**Remarks/Arguments**

U.S. Patent Application No.: 09/854,712  
Amendment dated February 18, 2005  
Reply to Office Action of October 19, 2004

**Amendments to the Drawings:**

Fig. 2

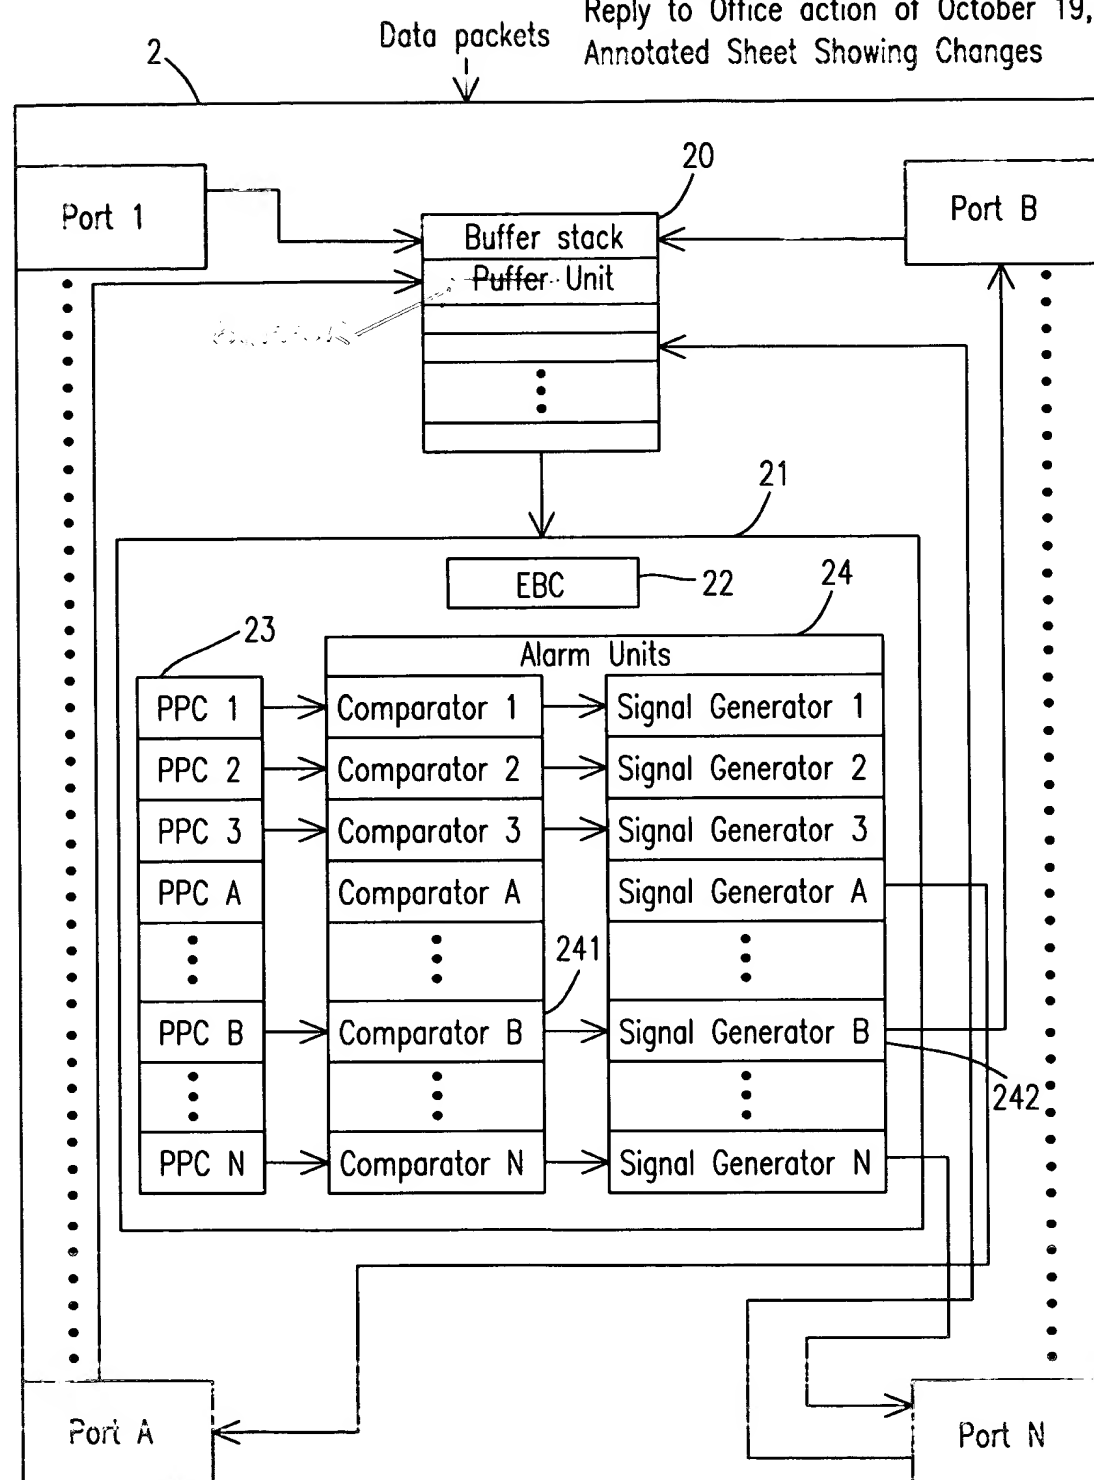
Please replace sheet 2 of the drawings, containing Figure 2, with replacement sheet 2, in which Figure 2 has been amended by correcting the spelling of the word "Buffer" from "Puffer". An annotated Sheet showing the change is also enclosed herewith.
